Project	<b>IEEE 802.16 Broadband Wireless Access Working Group</b> < <a href="http://ieee802.org/16">http://ieee802.org/16</a> >	
Title	<b>Comments on R-FCH</b>	
Date Submitted	<b>2008-05-09</b>	
Source(s)	Gamini Senarath, Israfil Bahceci, Hang Zhang, Peiying Zhu, Wen Tong, Derek Yu, Sun Sheng, Mark Naden Nortel Networks 3500 Carling Avenue Ottawa, Ontario K2H 8E9	E-mail: <a href="mailto:gamini@nortel.com">gamini@nortel.com</a>
Re:	IEEE 802.16-08/020: "IEEE 802.16 Working Group Letter Ballot Recirc. #28b: Announcement"	
Abstract	This contribution proposes remedies to the dynamic frame configuration in IEEE802.16j/D4.	
Purpose	Discuss and adopt proposed text in TG16j	
Notice	<i>This document does not represent the agreed views of the IEEE 802.16 Working Group or any of its subgroups. It represents only the views of the participants listed in the "Source(s)" field above. It is offered as a basis for discussion. It is not binding on the contributor(s), who reserve(s) the right to add, amend or withdraw material contained herein.</i>

## Comments on R-FCH

*Senarath Gamini, Israfil Bahceci, Hang Zhang, Peiyong Zhu, Wen Tong, Derek Yu, Sun Sheng, Mark Naden*  
*Nortel*

Figure 1 R-zone conflict in dynamic update along a 2-hop path

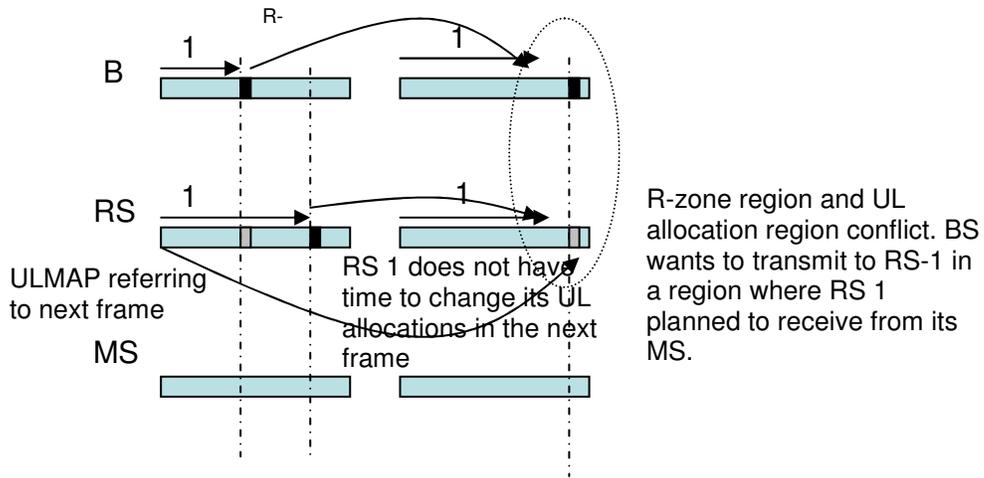
Consider a path where the MS is 2 hops away from the MR-BS, e.g., there is one RS in along the path. During the operational mode, if there is no update in frame configuration, the RS can schedule its access DL and UL without any problem. Now, assume that R-FCH/R-MAP occurs at every frame, and that the R-zone location needs to be updated at some frame-k. At this frame, the RS receives the R-FCH/R-MAP at its current location and expects to receive the one at frame-(k+1) in its new offset indicated by the R-Zone Location. However, such an update may conflict with RS's current UL scheduling since the UL MAP it already transmitted at frame-k provides allocation information at frame-(k+1). The RS has no time to update its UL allocation.

1. The MR-BS can keep track of maximum hop count in its site. Denote by  $N$  the maximum hop number among all MSs in the site. The maximum hop number determines the maximum propagation delay of R-FCH from MR-BS to the furthest access RS. In addition, the UL allocations in the R-MAP from an RS at hop- $h$  is relative to

frames for any new frame configuration to take affect so that any RS along a path can successfully implement any of its resource allocation based on the previous configuration and update its resource allocation for the new frame configuration for the upcoming frames. Thus, if R-Zone Location of R-FCH from the MR-BS is changed, the new offset shall be affective at the frame where  $(L+1)^{\text{th}}$  transmission of R-FCH takes place.

2. If an RS at hop- $h$  receives an R-Zone Location information that is not the same as the one it receives from the previous R-FCH, it should apply the new configuration after  $L-h+1$  R-FCH transmissions and until then, it shall continue to process allocation information and its resource allocations according to the previous frame configuration. This is because an RS can transmit its updated R-FCH only after it receives the updated R-FCH from its superordinate station. Therefore, each hop adds one R-FCH transmission delay for the new R-FCH to arrive the next hop RS.

Figure 2 R-zone conflict in dynamic update along a 3-hop path

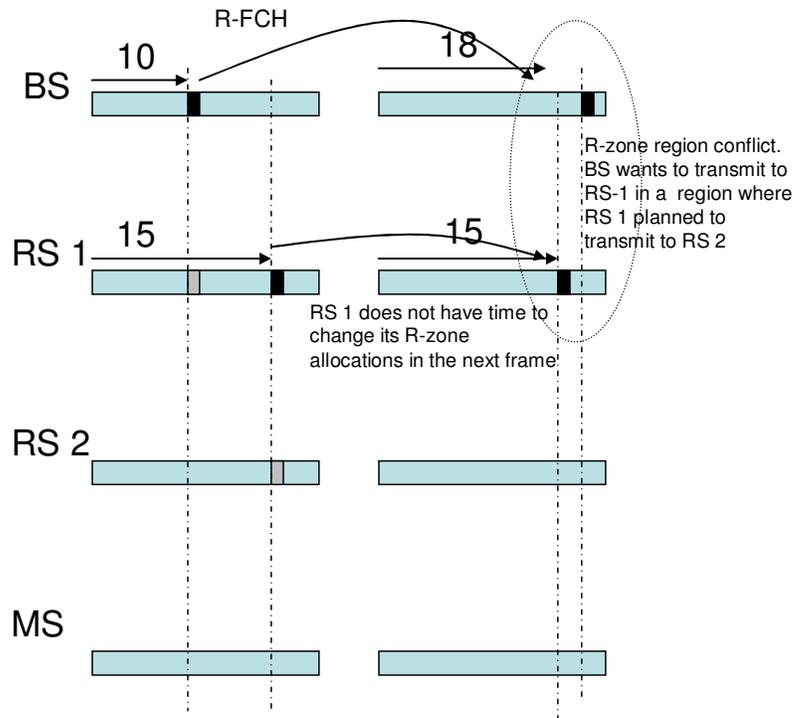
In case of more than two hops, as depicted in Figure 2, any update at MR-BS may result in conflict at both relay zones and access zones resource allocation since the intermediate RSs will not have sufficient allowance to update their scheduling according to new frame structures.

Figure 3 R-FCH with R-zone location field indicating the tx relay zone in the second frame instead of the first frame. A 3-hop path

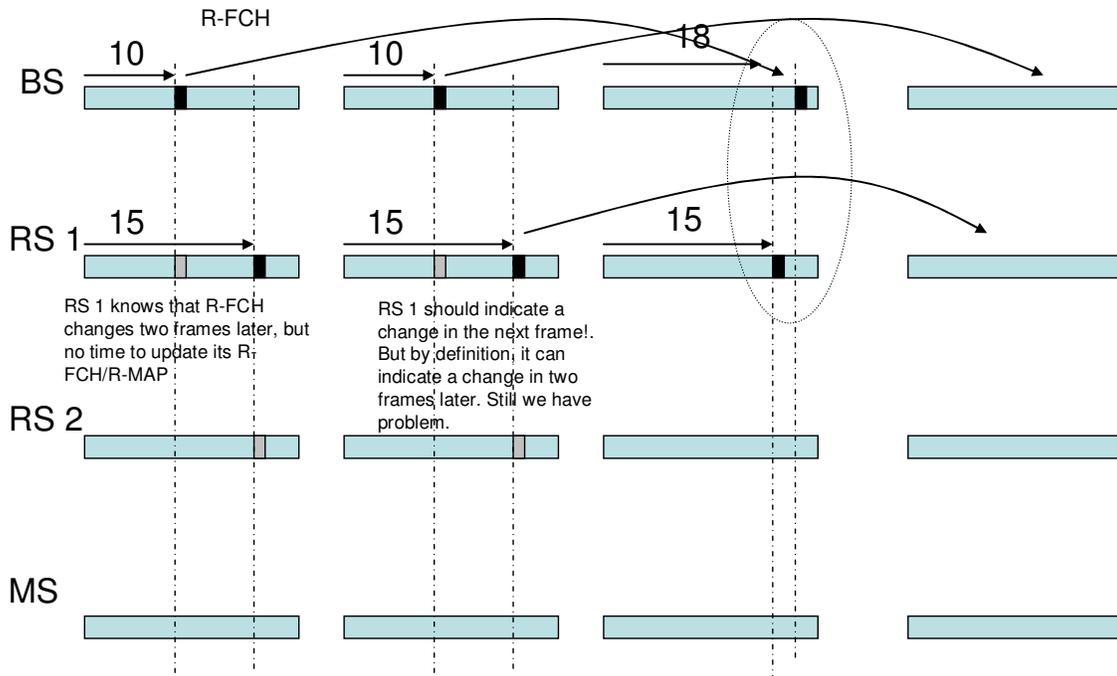
One solution seems to update the R-zone indication field definition so that that field gives the location of the

second or a later R-FCH transmission after the current one. In this case, we may still have problem as shown in Figure 3. Even if RS may have enough time to update its scheduling for the second frame, the R-zone location will indicate the R-FCH for the second frame, but not the next frame, which in fact should be informed to the subordinate RS. That is, the number of frames that need to be skipped for the R-zone location field to take affect needs to be varied according to the hop count of the RS.
